Questions/Answers

Solicitation 36C26323R00001

Upgrade Mental Health Lock Ward

Date: October 25, 2022	Project: VA FM Upgrade Mental Health Lock Ward
To: Stone Group Architects	Project #: VAMC 68-20-102 WPE: BR21045
From: West Plains Engineering 1750 Rand Road Rapid City, SD 57702	Project Location: Ft. Meade, SD Addendum #: Addendum 0001

B. WINDOW IN-FILL

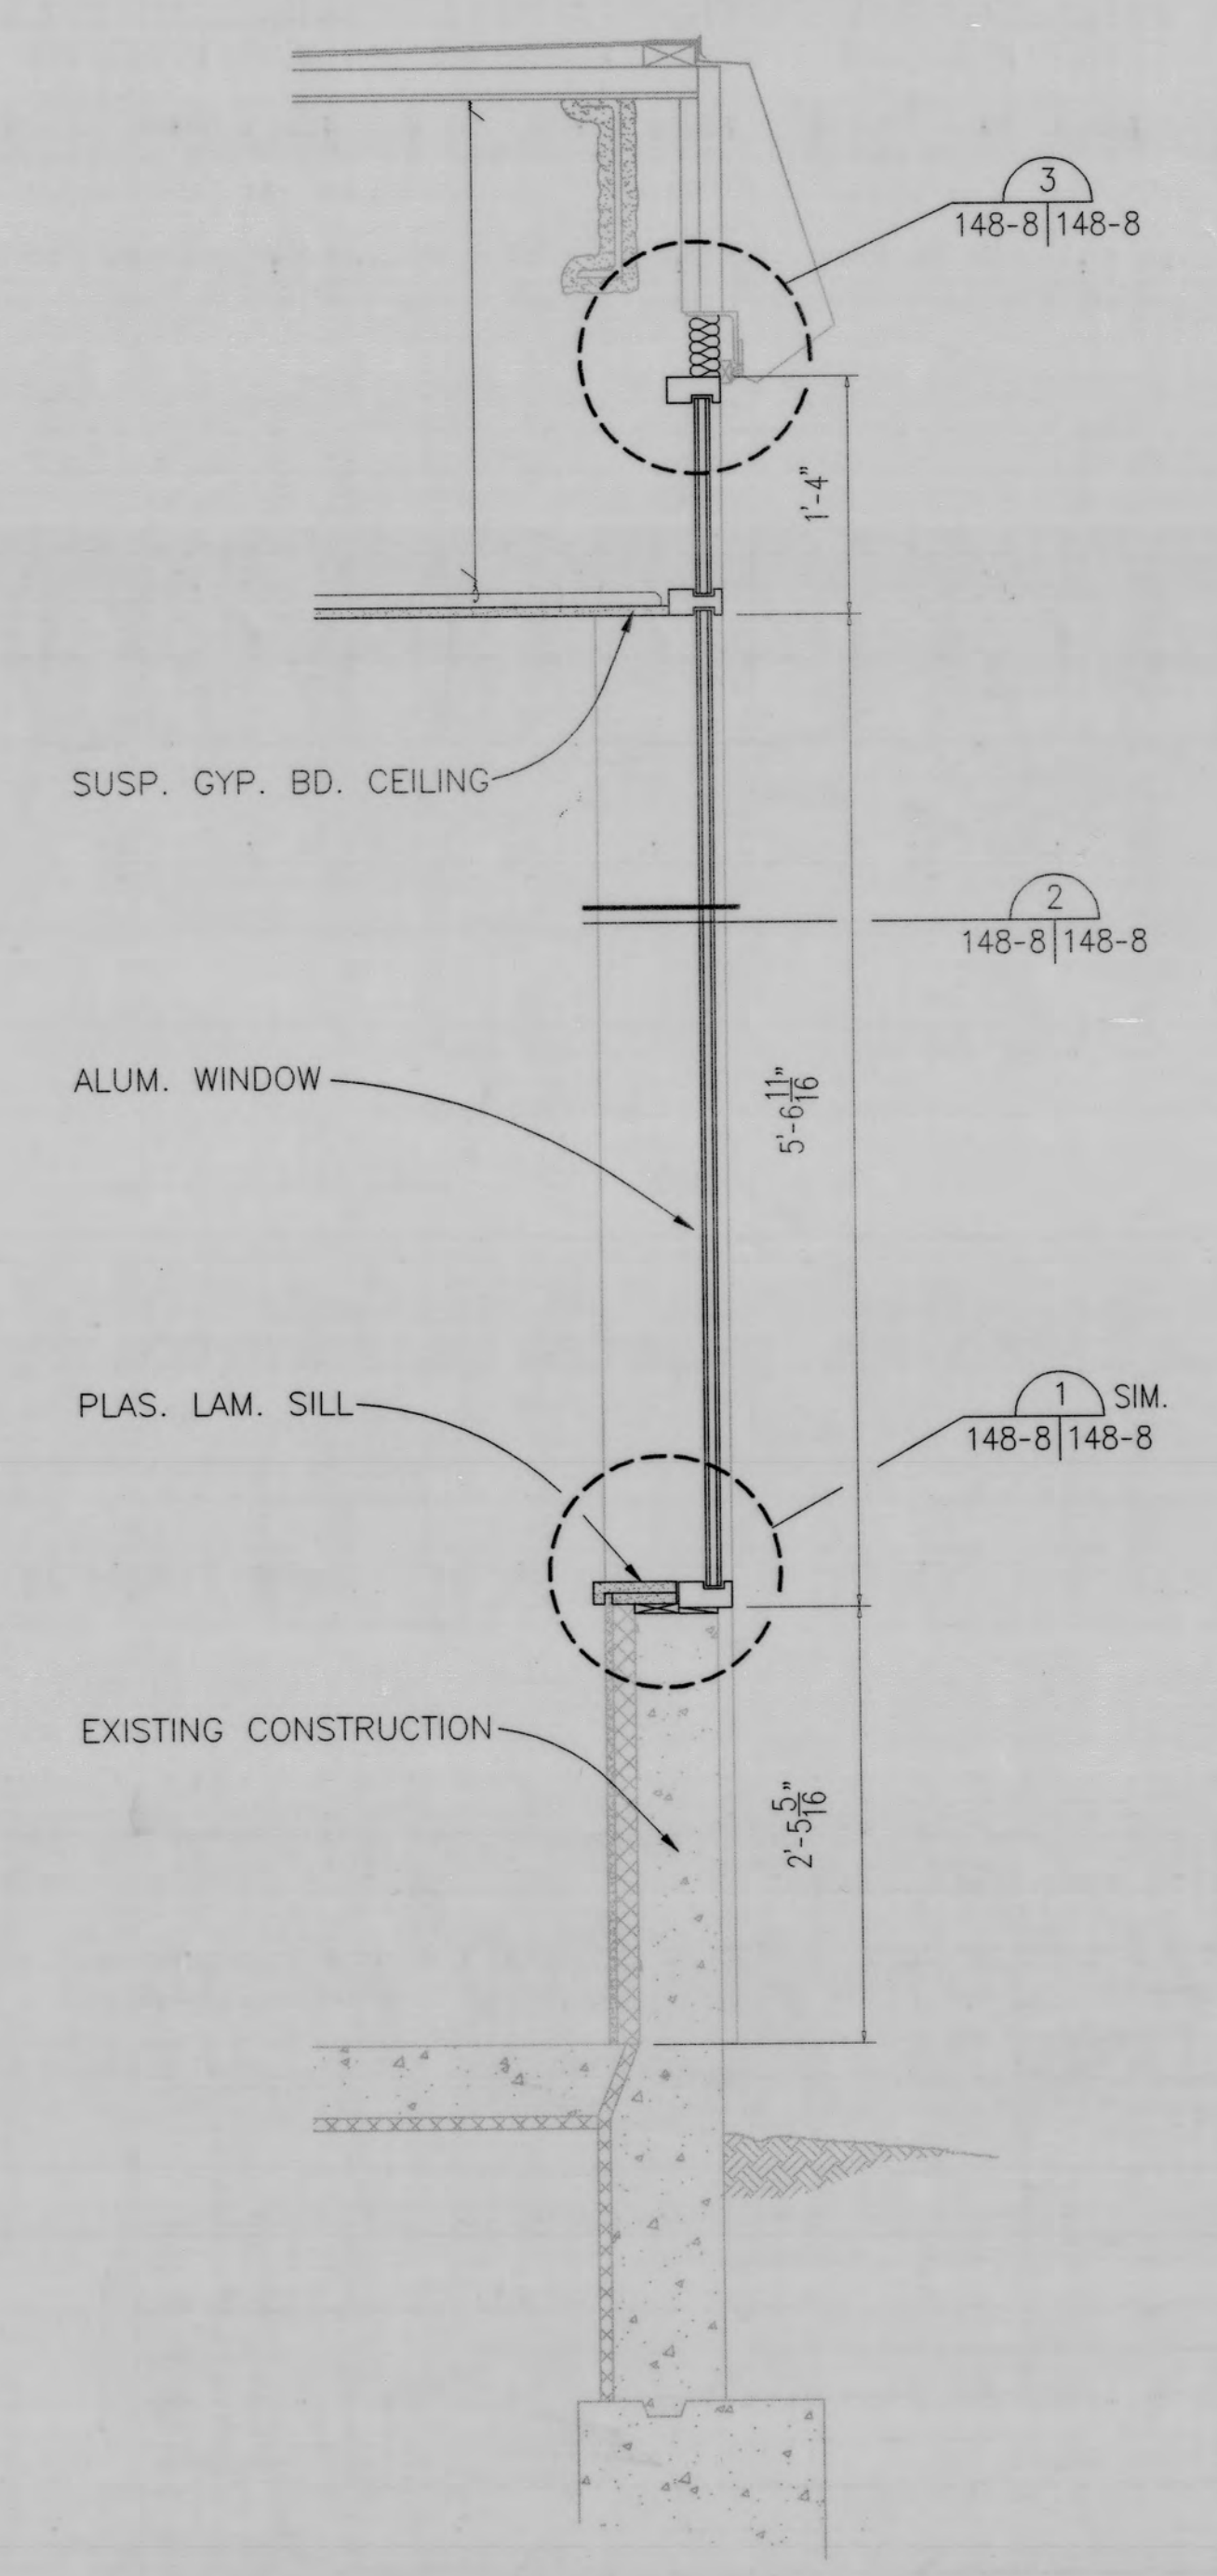
7	DIV 12 Please confirm the specs 12 36 00 are referring to window sills and not countertops. Please confirm what window types are to receive window sills. Please confirm Material, Colors, and edging.	AE: Yes, Division 12 is included for solid surface window sills. Windows getting sills are noted by keynote 6.60C on Sheet AE-101.
8	Period of Performance Does the PoP account for long lead times certain Divisions have when procuring material/equipment?	No - we have run into this issue on several of our contracts. If you feel that there are several long lead items, we can provide a limited NTP at the Pre-Construction meeting. When the submittals are approved and the items are expected, we can issue the Notice to proceed.
9	DIV 8 Please confirm that the only new storefront windows will be the (3) type C2 windows.	AE: yes the only fully new aluminum windows are the ones noted C2.
10	DIV 8 Per glass manufacturer the type D, D2, and D6 door lites are too small to be tempered laminated glass. They can be annealed lami but not tempered lami. Please advise	AE: we confirmed with a manufacturer that the size of the glass is not available as tempered laminated. Please provided annealed laminated glass for these lite only.

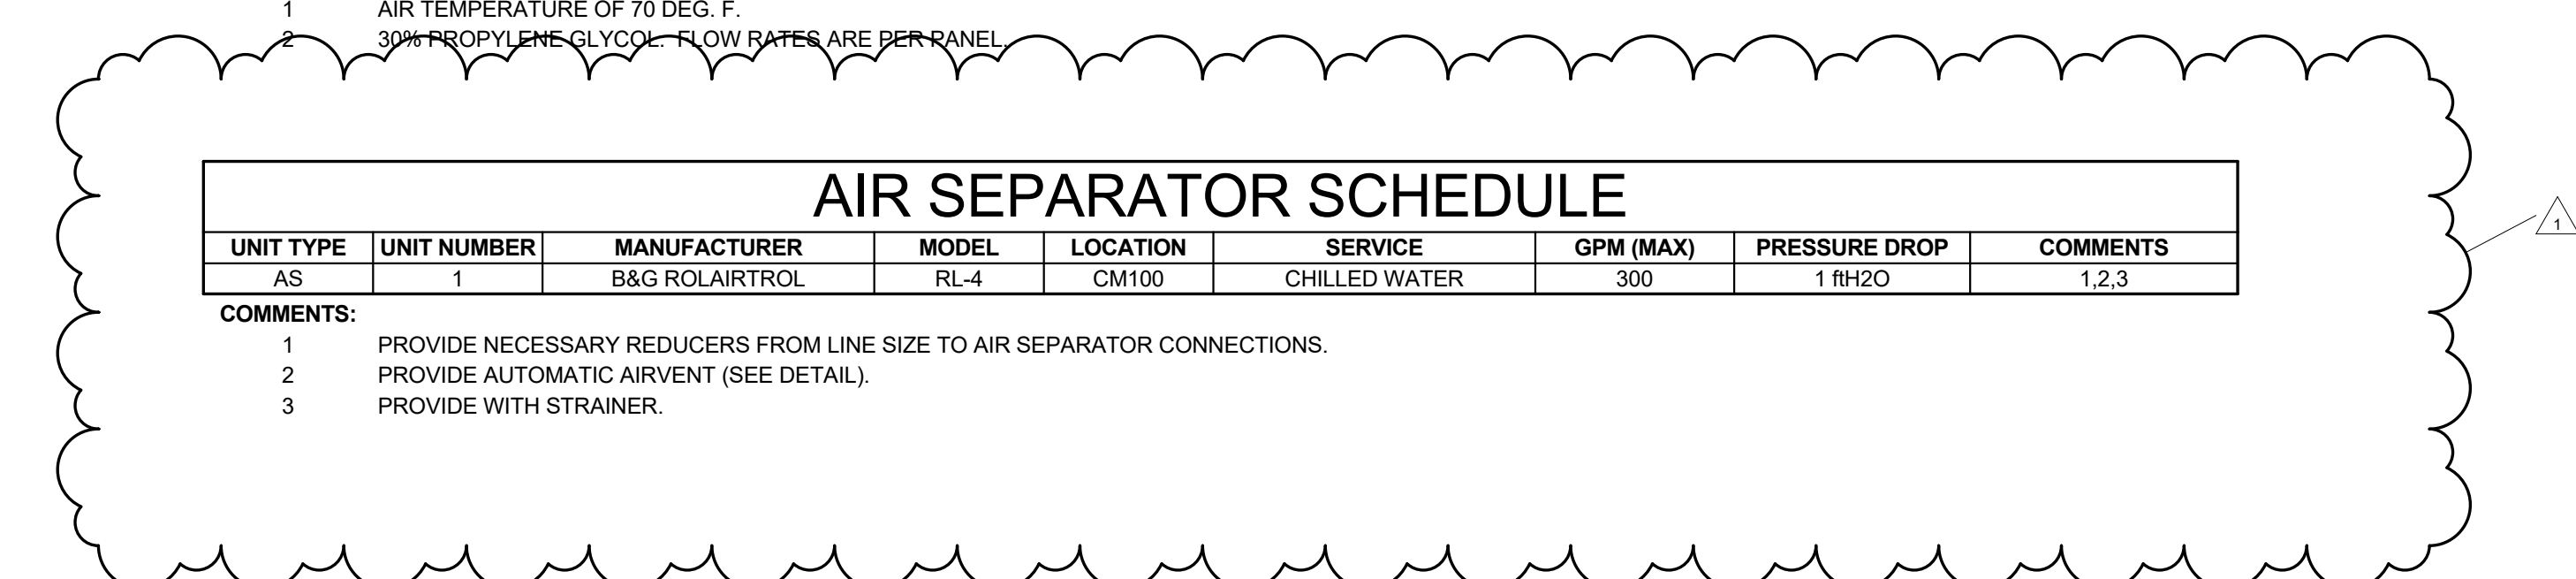
1. Refer to attached revised Sheet MJ504 for inclusion of Air Separator Schedule.
